SUB: Product Change Notifications (2)

Products Impacted by this notice: NTR series; SMT Thin Film Chip Resistors

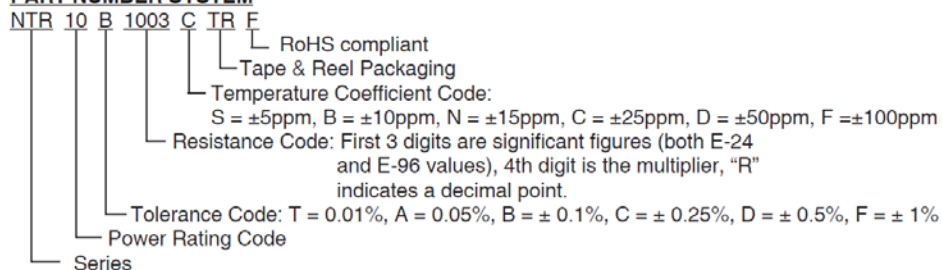
Expanded available resistance values for 0201 case size changed from "E-24" to both "E-24" & "E-96" resistance values

REASON FOR CHANGE: Expanded resistance value offering in E96 resistance values
